ADDENDUM NO. 1

JOB NO. 17-10, WP2020 #KW-07
Rehabilitate Paua Valley Tank No. 1, 0.5 MG Concrete
Kekaha Water System
Kekaha, Kaua'i, Hawai'i

Item 1: Pre-Bid Conference Meeting Minutes

SITE AND GRADING PLAN

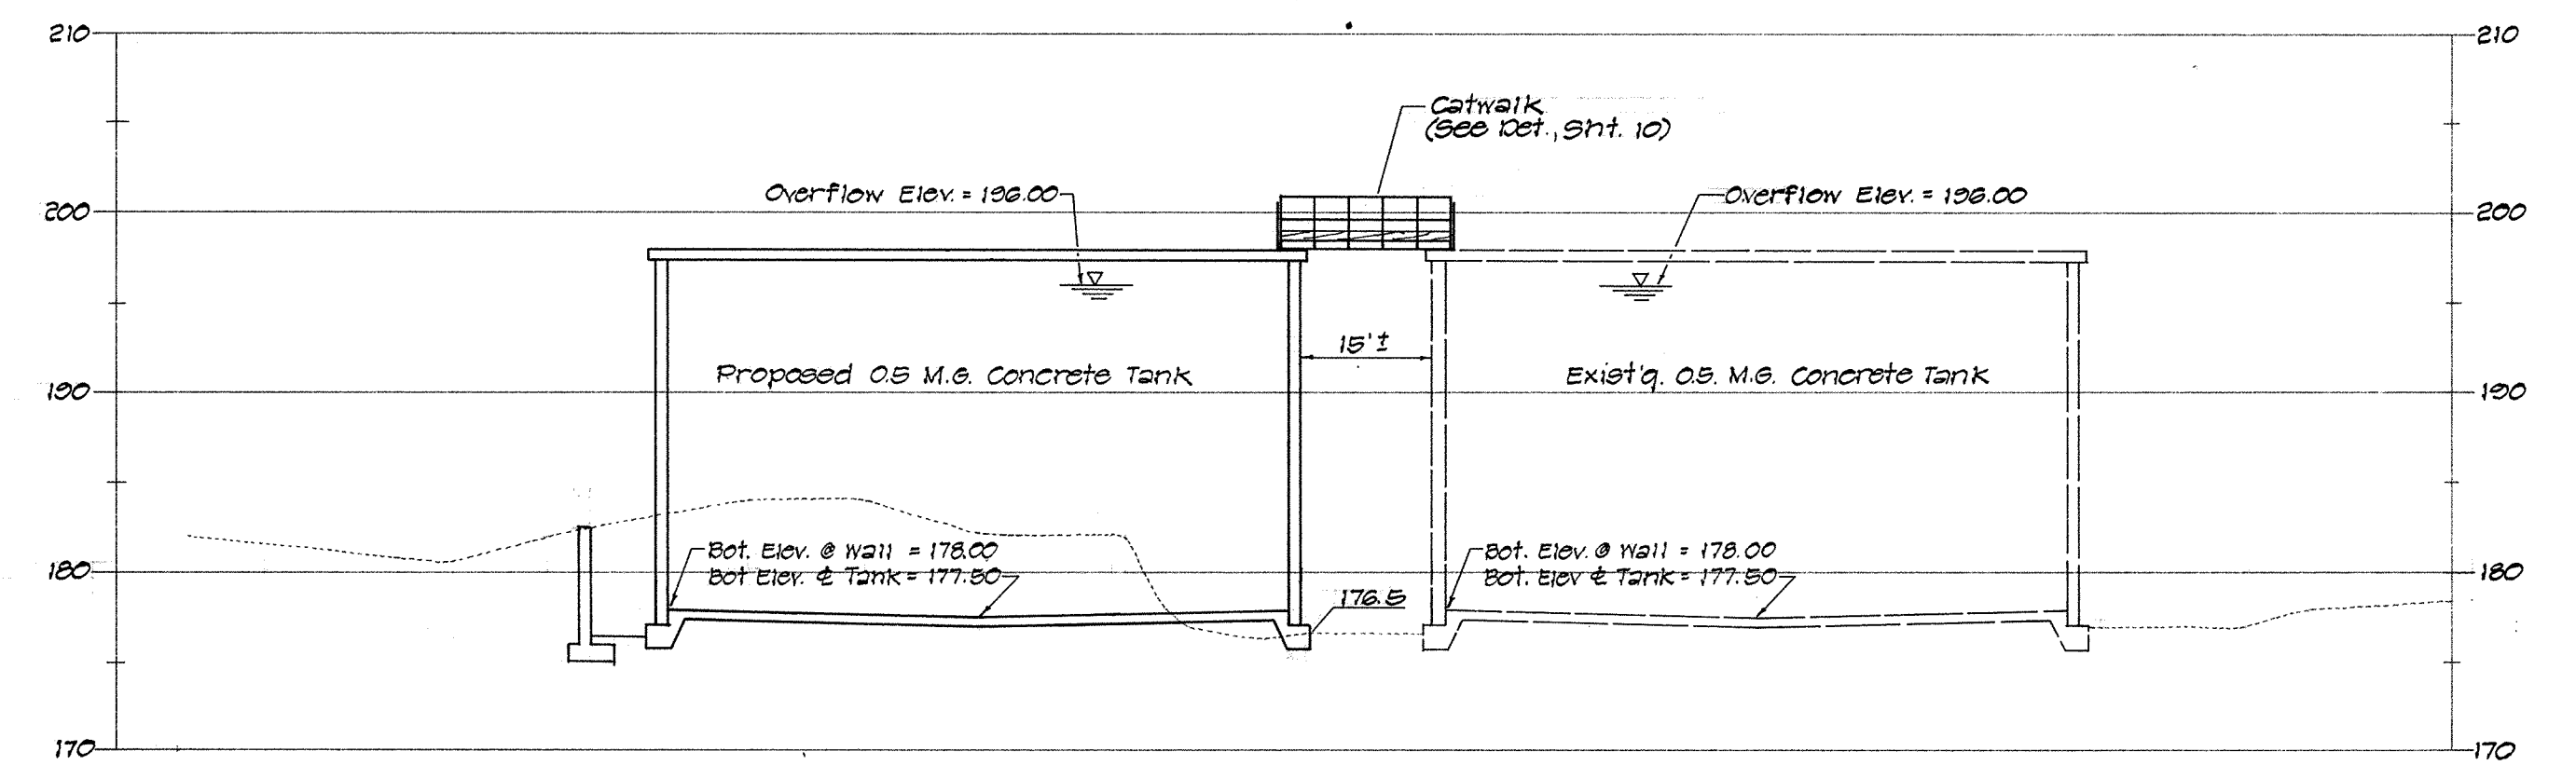
Q: Where to do we physically break the waterline to isolate tank work?

A: See attached sheet "Site and Grading Plan", Sheet 3.
